<b>Safety and Airspace Regulation Group</b>	<b>DAP 1C</b>
Doc Type:	Annex C	Version: 1/2012
Title:	<b>Airspace Change Proposal Operational Assessment</b>	Page 1 of 29

<b>Title of Airspace Change Proposal</b>	<b>SOUTH COAST CHANGES – Module E of LAMP Phase 1a ACP</b>
<b>Change Sponsor</b>	<b>NATS (NERL)</b>
<b>SARG Project Leader</b>	<b>[REDACTED]</b>

<b>Case Study commencement date</b>	Issue 1 Received 17 February 2015. Commenced Case Study 4 March 2015 Issue 2 Received 20 March 2015
<b>Case Study report as at</b>	27 July 2015 – Version 1.1; updated 10 Sep 15 as Version 1.2

Figure 6 Proposed arrival FPL routes (illustration THIS CHART UPDATED)

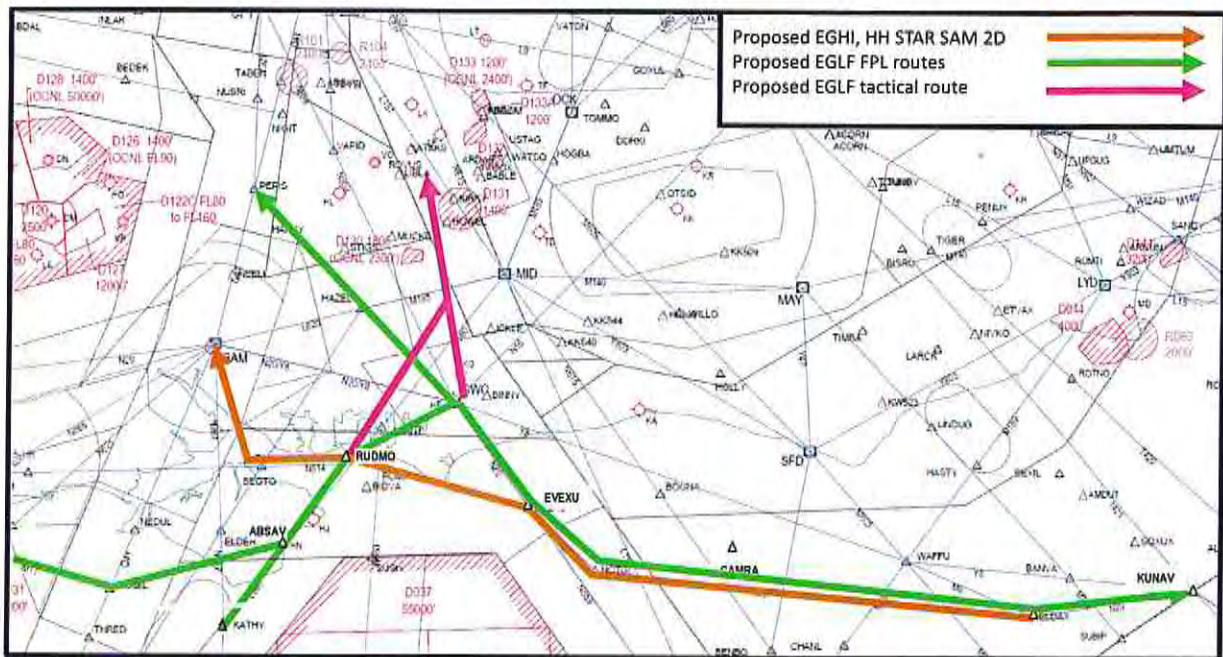
A new ATS route N20 will feed the EGHI & EGHH STAR and a Farnborough (EGLF) arrival route. N20 will route: KUNAV-ELDAX-NOTGI-EVEXU-GWC-SAM. See ACP page 14 Fig 6 (Attachment 1).

Revised flight planned arrival routes (see ACP page 14 Fig 6) (Attachment 1) for traffic inbound to EGLF for traffic:

- from the south (KATHY & ORTAC) routing KATHY-ABSAV-RUDMO-GWC-PEPIS
- from the southwest to route GIBSO-BILNI-KUMIL-ABSAV-RUDMO-GWC-PEPIS.
- From the Paris FIR routing along a new ATS route N20 - see below.

At the ACP paragraph 5.3, there is a description of how arrivals and departures will be routed as shown in ACP Fig 6&7 to supplement the above information and expected tactical use is highlighted in paragraph 5.4 (this relates to Figs D8&9 in the TAG Consultation Document at Attachment 2&3).

Figure 6 shows the procedures for arrivals. Farnborough arrivals from the south will route via ABSAV to the proposed hold at RUDMO at FL70. The route then continues GWC PEPIS from where there is a defined radio fail procedure via the TAGOX hold (this is no change from today).

From the east Farnborough arrivals route via GWC with contingency hold at PEPIS.

Southampton and Bournemouth arrivals would also route via the proposed hold at RUDMO, FL70 the lowest level of the hold.

Figure 7 Proposed DVR departure FPL routes relevant to this proposal (illustration)

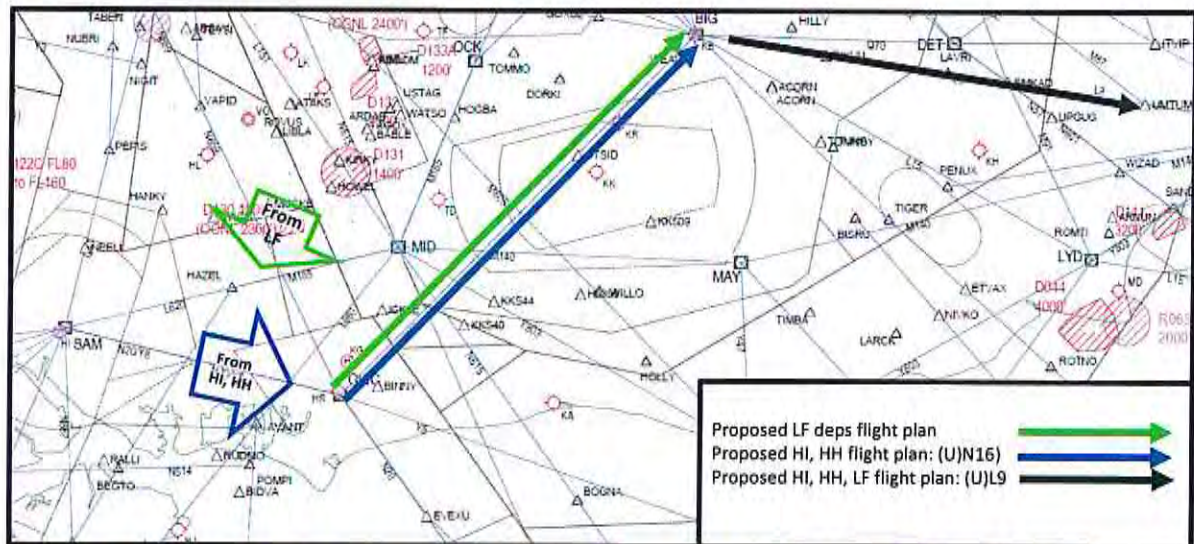
A revised flight planned routing for 'Solent' departures from EGHI and EGHH routing via Dover (DVR) VOR to Europe at Requested Flight Level (RFL) of FL200+ which will now route to Goodwood (GWC) VOR, then via a new ATS route (U)N16 from GWC-Biggin (BIG) VOR where it joins exiting route (U)L9 from BIG-DVR (it is an AIP flight planned route and not a SID) – see ACP page 14 Fig 7 (Attachment 1). Currently, these departures route GWC-SFD-DVR.

A revised flight planned routing for EGLF departures (see ACP page 14 Fig 7- Attachment 1) routing via DVR VOR to Europe at RFL of FL200+ which will now route to HAZEL- GWC VOR, then a new ATS route (U)N16 from GWC-BIG where it joins existing route (U)L9 from BIG-DVR (it is an AIP flight planned route and not a SID). Currently, these departures route GWC-SFD-DVR.

Figure D8: Proposed SOUTHAMPTON arrival flows from the east to both runways, 4,000ft-7,000ft

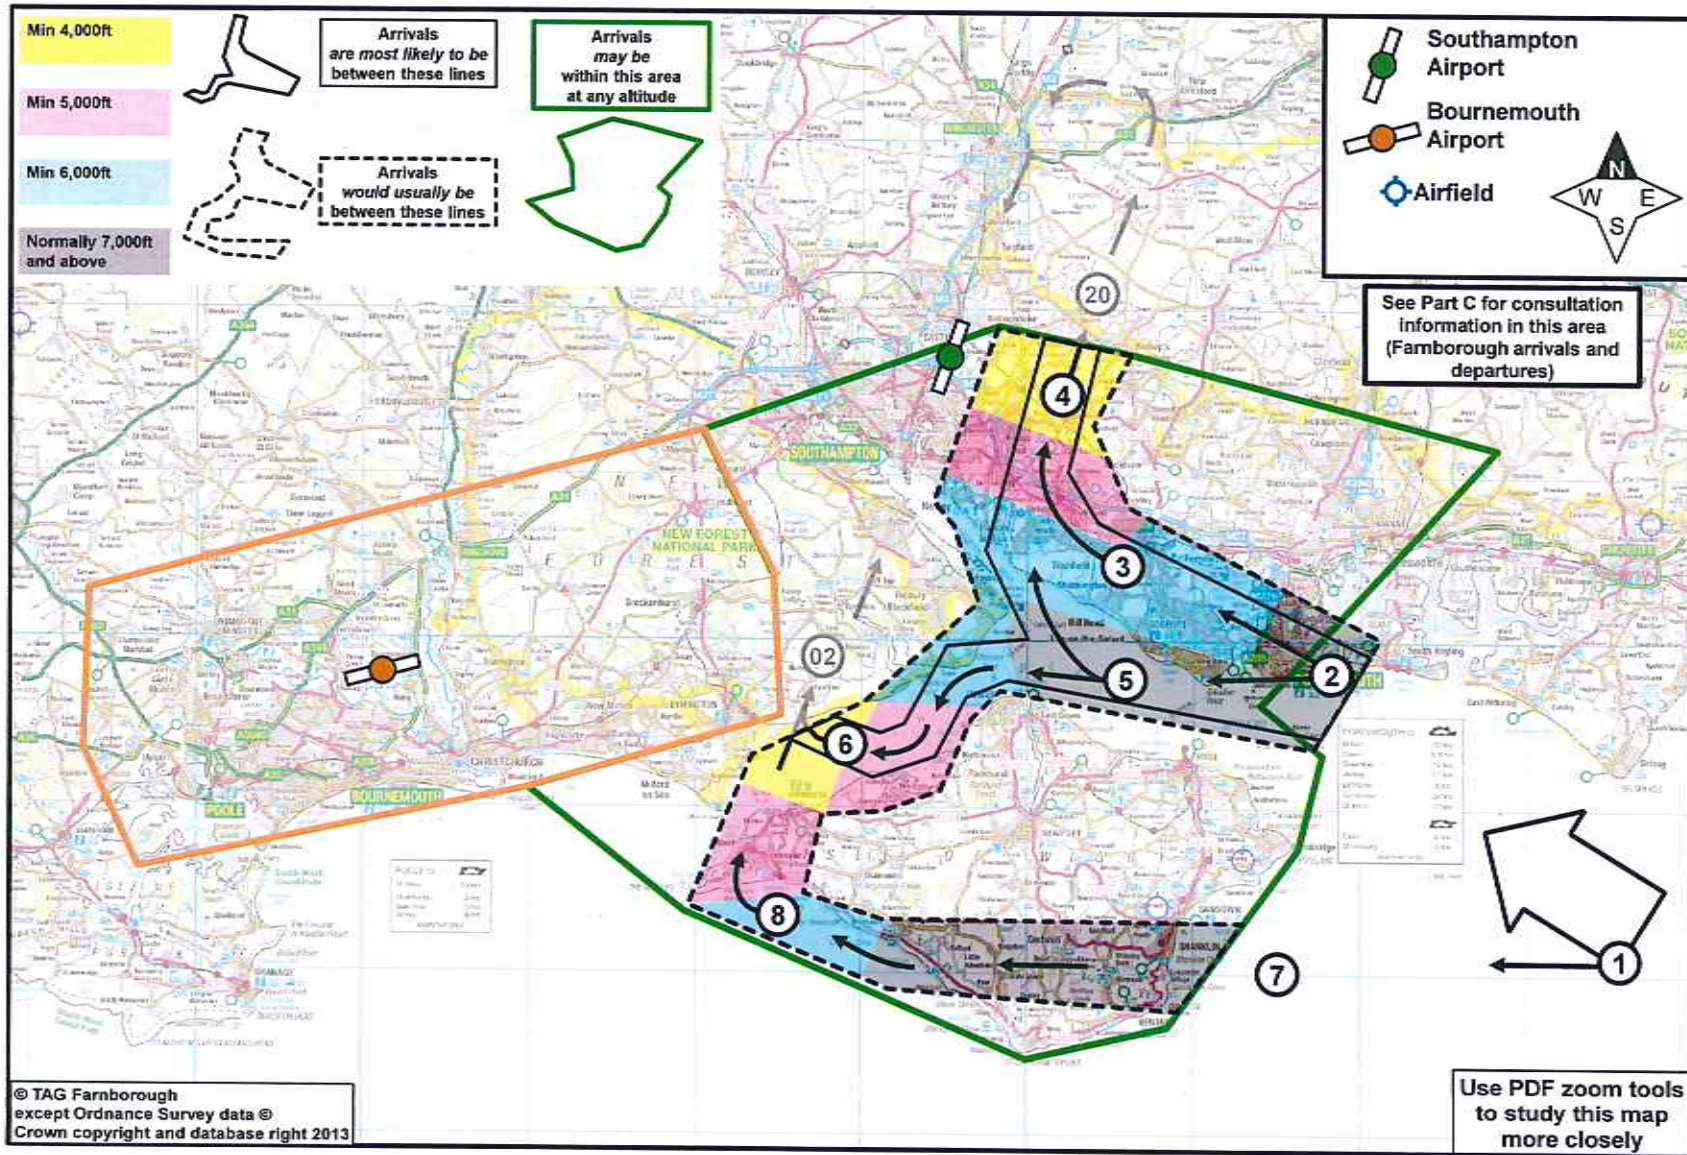
A revised 'Solent' SAM 2D Standard Arrival Route (STAR) for Southampton (EGHI) and Bournemouth (EGHH) arrivals which involves a re-alignment further south from a new position ELDAX (close to the Flight Information Region (FIR) FIR Bdy at KUNAV), passing south of Selsey Bill, along the Solent before turning north to Southampton (SAM) VOR (it previously was aligned to GWC VOR) then SAM. The new routing is: ELDAX-NOTGI-EVEXU-RUDMO-MIVLA-SAM and includes a contingency hold at RUDMO. The ACP page 14 Fig 6 (Attachment 1) shows the proposed changes. Revised radar vectoring from the STAR is also proposed for both airports (see Consultation Document Figs D 8 & 9 – Attachments 2 & 3).

Figure 5 Proposed CAS volumes overlaid on current VFR chart (illustration)  
See Section 0.1

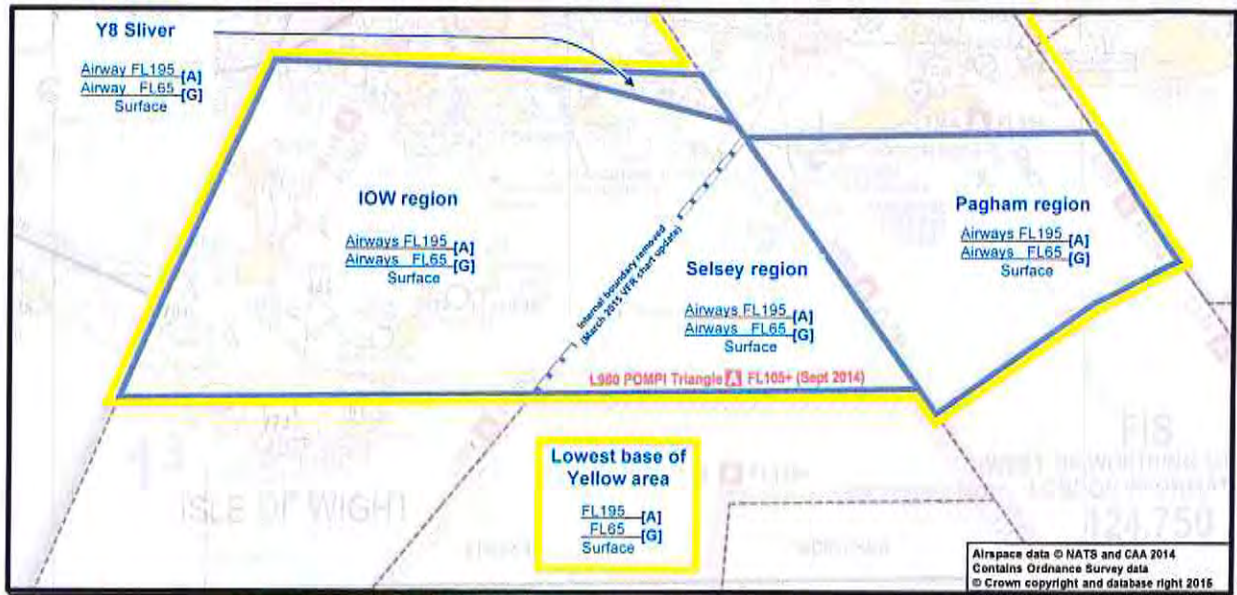
Lowering of Controlled Airspace (CAS) to FL 65 in 4 areas depicted in the ACP page 13 Fig 5 and page 45 Fig 10 in the Isle of Wight, Selsey and Pagham regions and a Y8 sliver of CAS to the east of Portsmouth (see Attachment 4).

The original TAG consultation included a larger area south of the Isle of Wight where the sponsor proposed to lower CAS from FL 105 to FL 65, lower the Y8 sliver east of Portsmouth to 5500ft, and lower part of N859 from FL 75 to FL 65 in the Pagham region (see ACP page 43-46 (Figs 8-11) and the Feedback Report pages 10-12) to see existing, proposed and refined CAS after consultation). As shown in ACP Fig 10, following consultation, the CAS at the southern section of the Isle of Wight section and the Y8 sliver have been modified and changed to a uniform lower limit of FL65. A summary of the feedback from aviation users was covered in the Consultation **Feedback Report, Pages 8-15 at Section 4.**

Although some GA airspace users will be affected over the Isle of Wight and the adjacent proposed CAS where the lower limit will drop to FL 65, NATS/TAG concluded they could reduce the volume of CAS originally proposed and this would partly mitigate some objections. Whilst this modification to the volume of Class A airspace (over the sea) was applied to the original airspace design, it was unclear from the ACP documentation what action was actually pursued to engage with any particular GA operators. (Note: on request 10 Sep 15)

Therefore, in order to reduce the impact to specific general handling/stalling and spinning exercises conducted above FL 65, it is recommended that, as a condition of the approval of the lowering of controlled airspace over and adjacent to the Isle of Wight, that NATS is to engage appropriate GA stakeholders who conduct these particular sorties to determine what sorties can be accommodated by establishing a MoU/LoA to permit segregated activity to take place under conditions specified in the MoU/LoA, authorised by an exemption to enter Class A airspace under VFR in areas to be agreed over/adjacent to the Isle of Wight where the controlled airspace will drop to FL 65.
